# *SILVER BOW CREEK INVESTIGATION*

RESPONSES TO COMMENTS RECEIVED FROM  
ARCO COAL COMPANY ON THE WARM SPRINGS  
PONDS PHASE II REMEDIAL INVESTIGATION  
DATA SUMMARY REPORT

CH2M HILL, Inc.  
Helena, Montana

December, 1990

**FIGURE 2-15** AVERAGE ZINC CONCENTRATIONS; SS-19 TO PS-12  
SILVER BOW CREEK CERCLA; PHASE II REMEDIAL INVESTIGATION  
APRIL, 1988

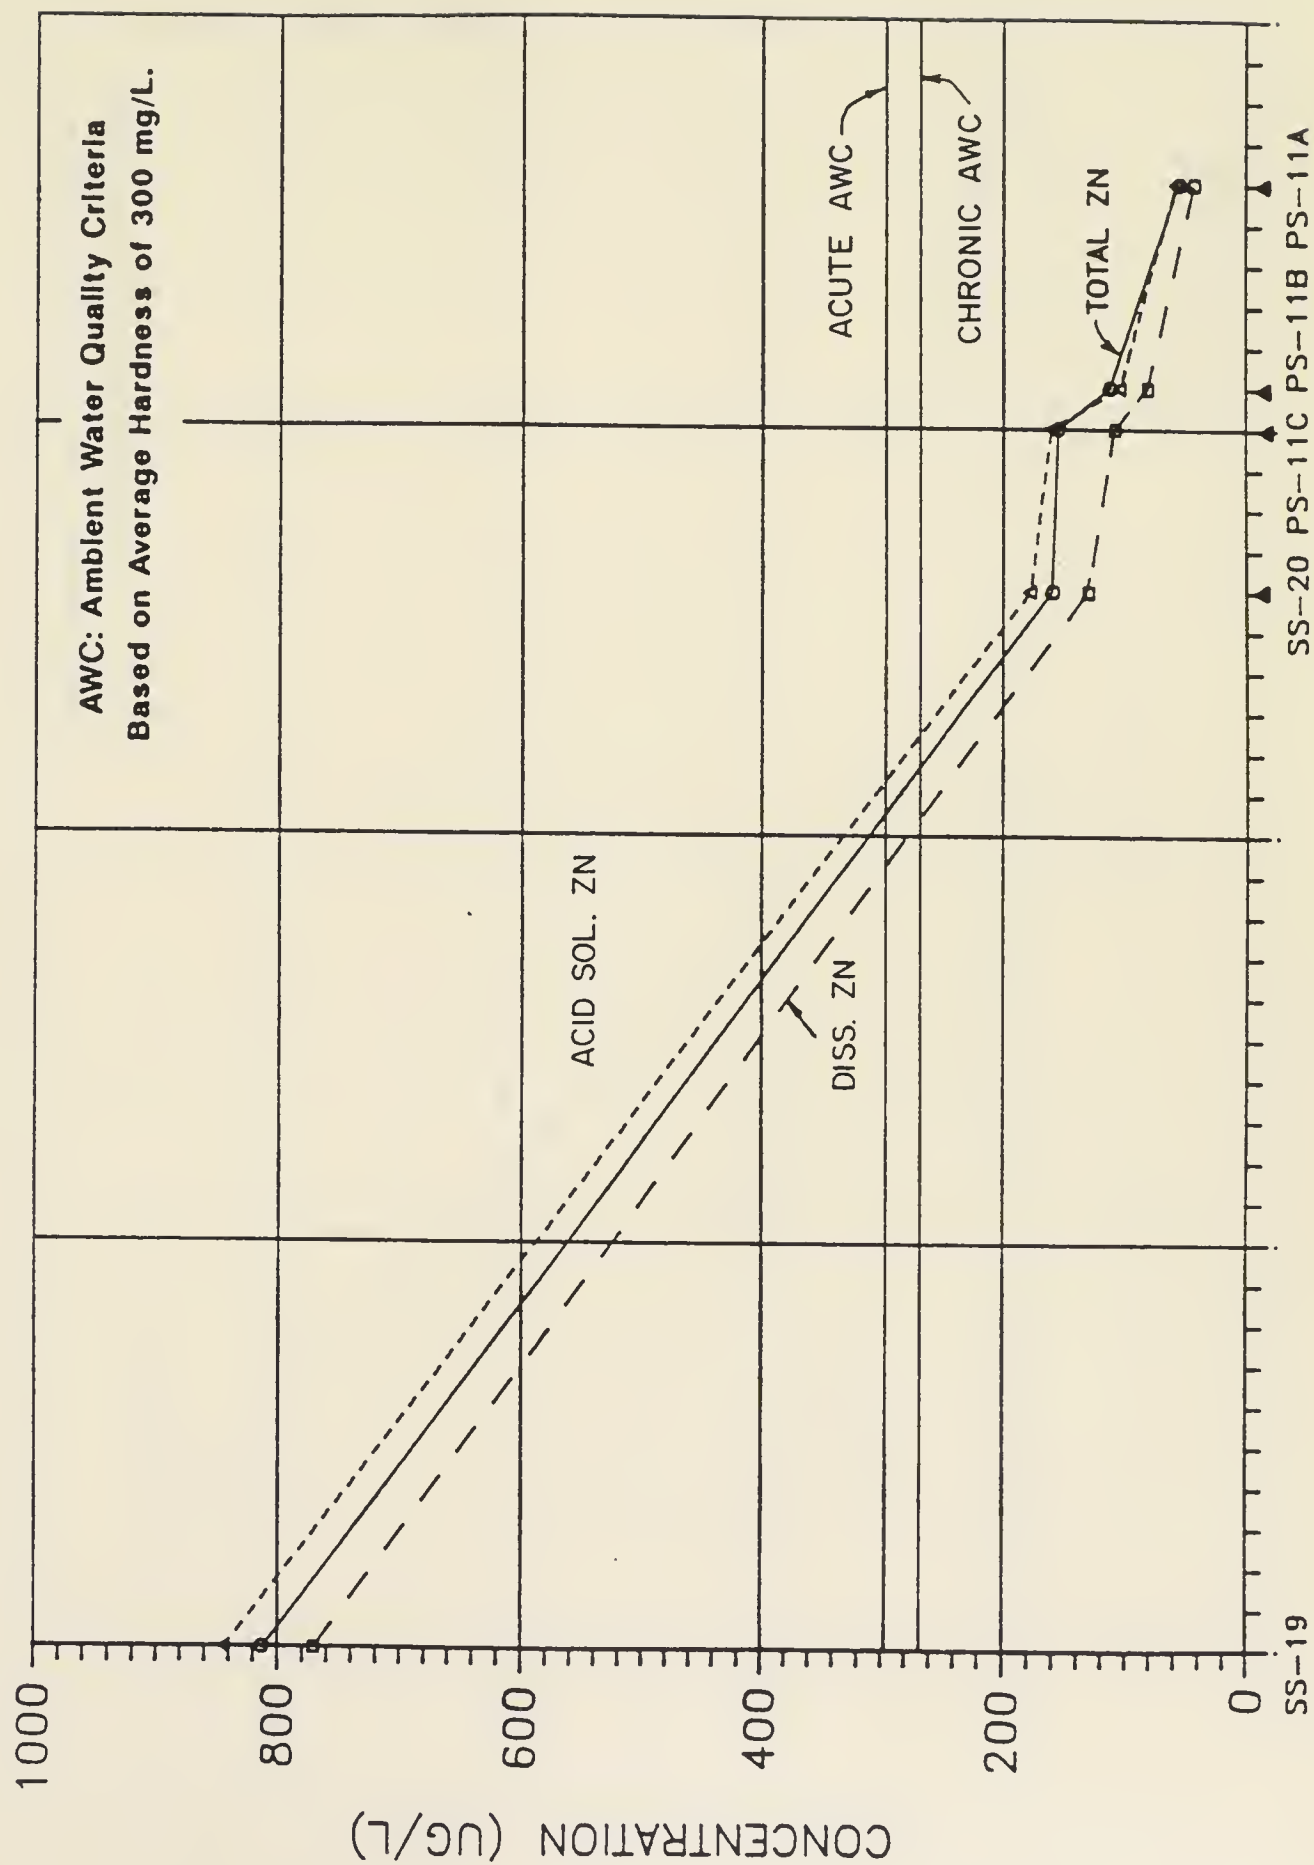
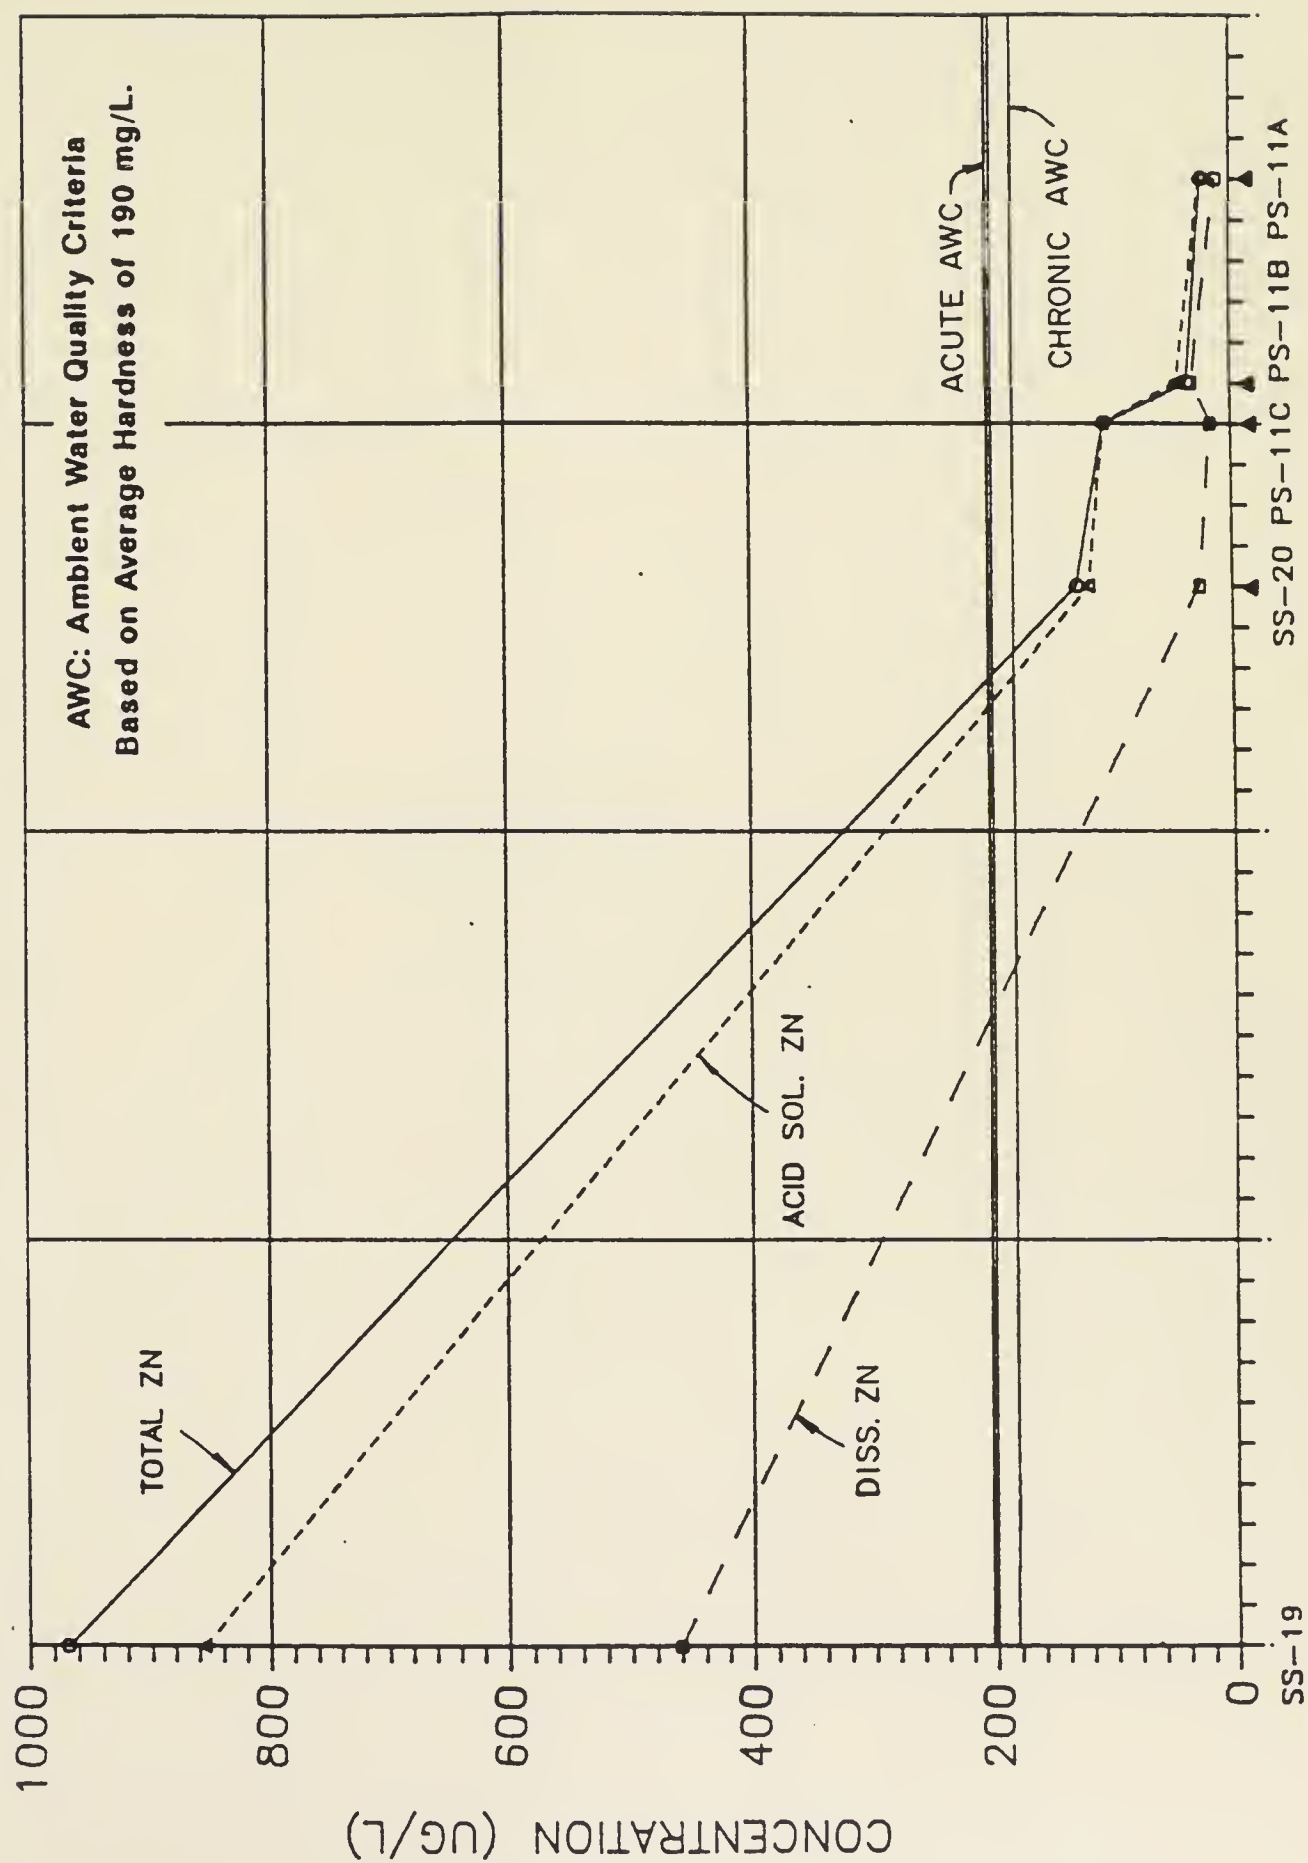
15. *Values for the zinc ambient water quality criterion (i.e. Gold Book) shown in Figures 2-13, 2-14, 2-15, 2-18, and 2-19 are incorrect and should be corrected. These figures all shown chronic AWC values below 100 ug/L. Based on a minimum hardness of 160 mg/l as CaCO<sub>3</sub>, the acute concentration criterion for zinc should be at least 157 ug/L (52 Federal Register 6213, May 2, 1987). As a result, Table 2-4 is also incorrect and should be revised to reflect the correct water quality criterion. This will alter the number of samples exceeding the water quality criteria. The table should also list the actual numerical values being used for water quality criteria.*

Response: Values for the zinc ambient water quality criteria illustrated on Figures 2-13, 2-14, 2-15, 2-18, and 2-19 are incorrect. The correct values for these criteria include the following:

Figures 2-13, 2-14, 2-15, 2-18, and 2-19 have been revised and are included as Attachment A to this response document.

**ATTACHMENT B**

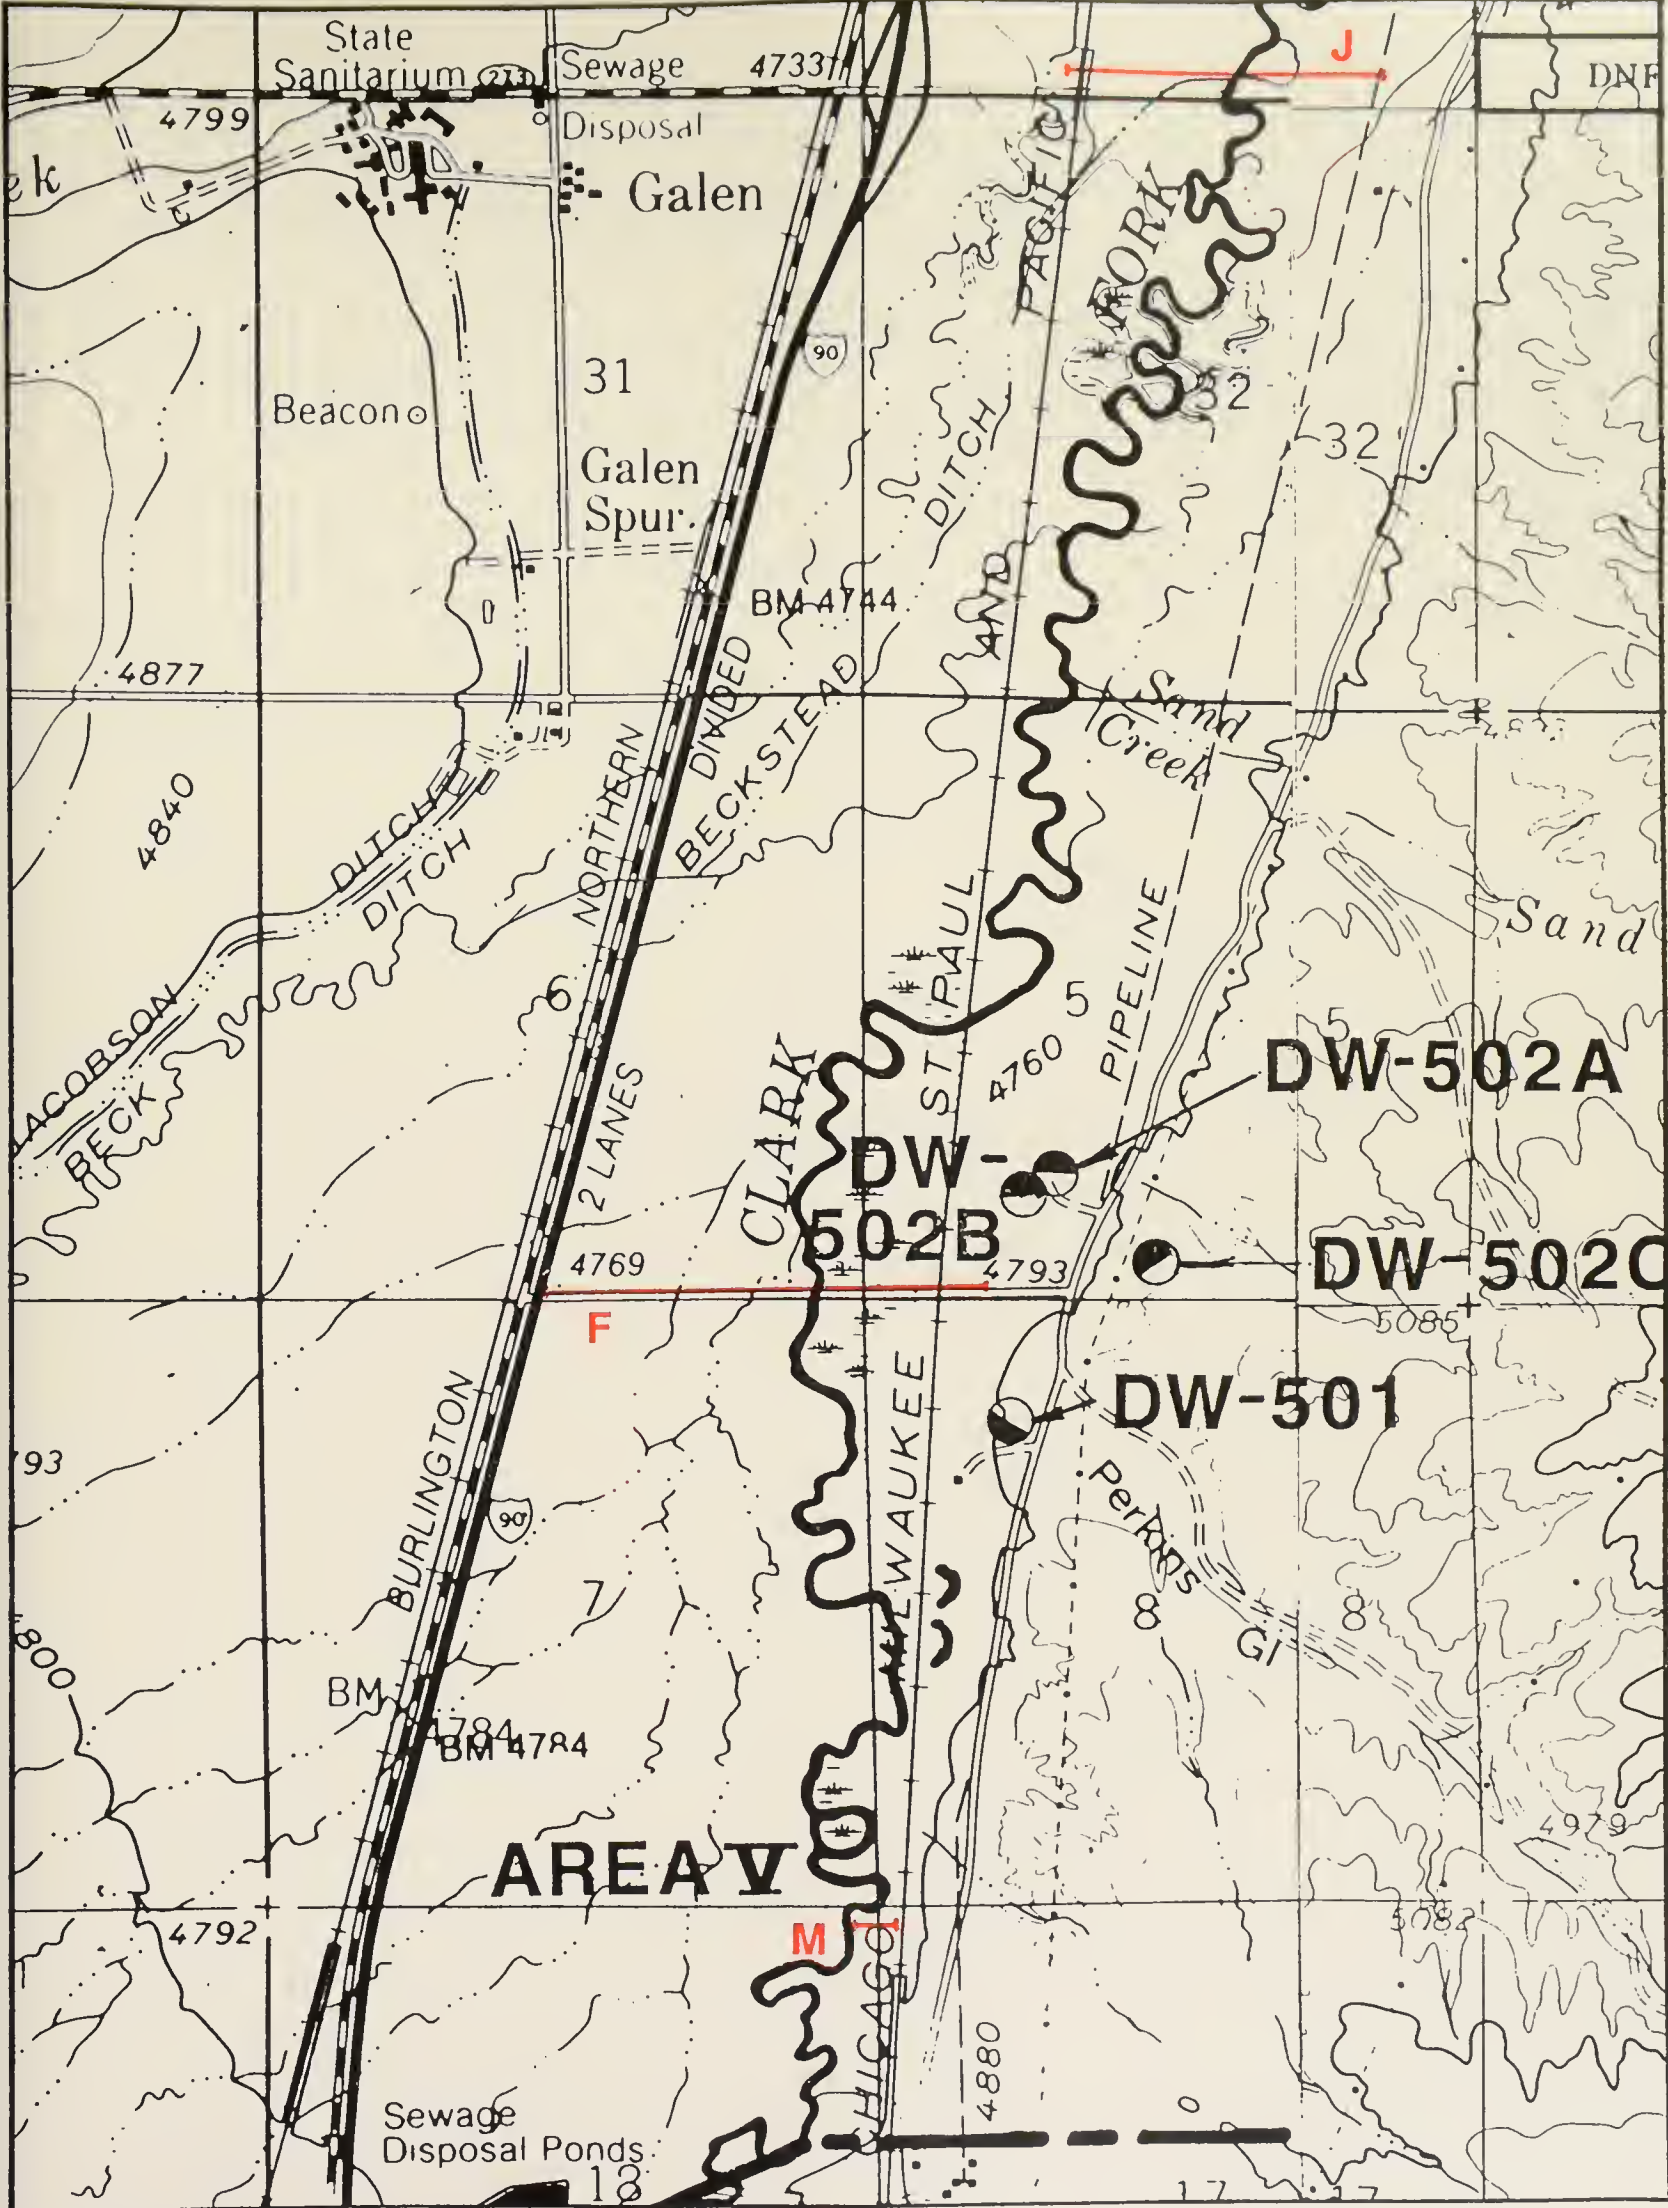
3. *All of the EM transects completed during the Phase II RI are not identified in any of the figures presented in the report. The EM survey field notes in Appendix B-1 indicate that transects F, J, M, and P were completed in addition to the transects identified in Figure 3-1. The report should be revised to include their locations and an interpretation of the EM survey results as compared to the other transect results, or a detailed explanation of why these particular sets of transect data were not discussed in this report.*

1. *Figures 3-2 and 3-3 illustrate an interpretation of the results of the EM surveys for the area below Pond 1 and the Mill-Willow Bypass. Neither of these figures include ranges of values for the following transects:*
  - o Upgradient transects (these are not clearly identified in the test or field notes)*
  - o Transects F, J, M, and P (locations not identified in Figure 3-1)*
  - o Transects A and O (location incomplete in Figure 3-1)*
  - o Transect N (data missing for the segment completed along the northwest side of Pond 1)*

Response: EM transects completed both south and north of the Warm Springs Ponds were not shown on Figures 3-1 through 3-3 because the coverage of the maps used in presenting RI data did not extend to these areas. Downgradient transects F, J, and M are shown in Attachment B of this response document.
